RECORD PLANS

PROPOSED IMPROVEMENT BRIDGE PROJECT FAIR HAVEN - RUTLAND COUNTY OF RUTLAND ELEVEN BRIDGES ON OR OVER US ROUTE 4

PROJECT DESCRIPTION: THIS PROJECT INVOLVES CLEANING, LEAD PAINT REMOVAL AND REPAINTING THE EXISTING STEEL SUPERSTRUCTURE MEMBERS AND MINOR ASSOCIATED WORK.

DIRECTOR OF PROGRAM DEVELOPMENT
APPROVED  DATE 6-20-12
PROJECT MANAGER : MARK SARGENT
PROJECT NAME : FAIR HAVEN - RUTLAND
PROJECT NUMBER : BHF BPNT (10)
SHEET 1 OF 28 SHEETS

BRIDGE NOTES:

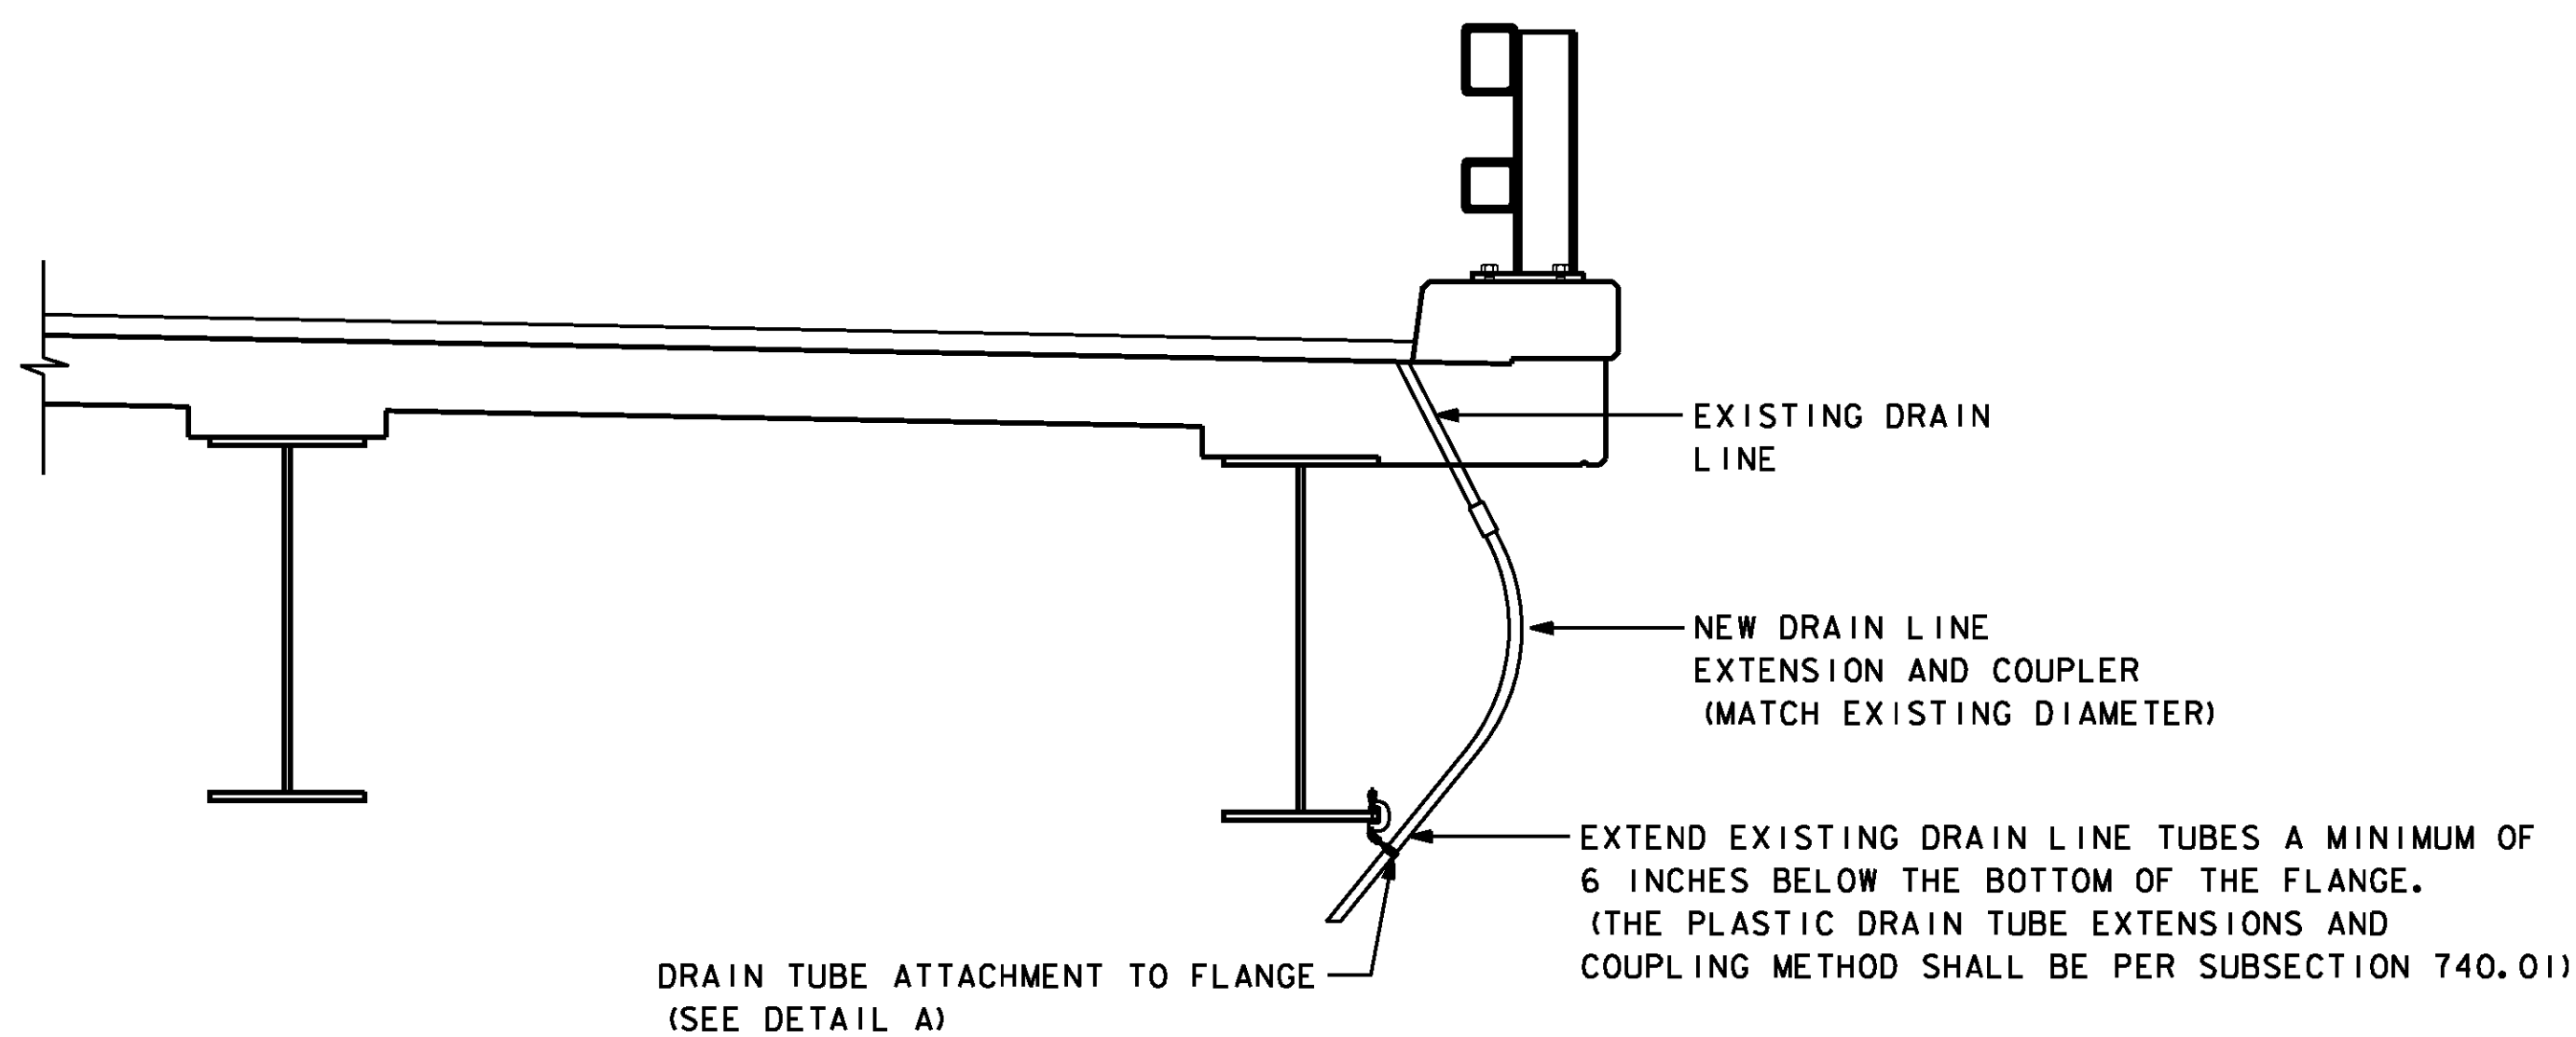
1. REMOVE GREASE COATING ON ENDS OF STEEL BEAMS, END CROSS MEMBERS AND BEARINGS
2. CLEAN AND PAINT EXISTING STEEL
3. REPAIR AND CLEAN BRIDGE SCUPPERS (REFER TO SHEET 4)
4. REPLACE DRAIN ON ~~WEST END~~ ONLY (REFER TO SHEET 3) EAST END
5. UTILITIES LOCATED ON NORTH SIDE OF BRIDGE (REFER TO PROJECT NOTE 7 ON THIS SHEET)
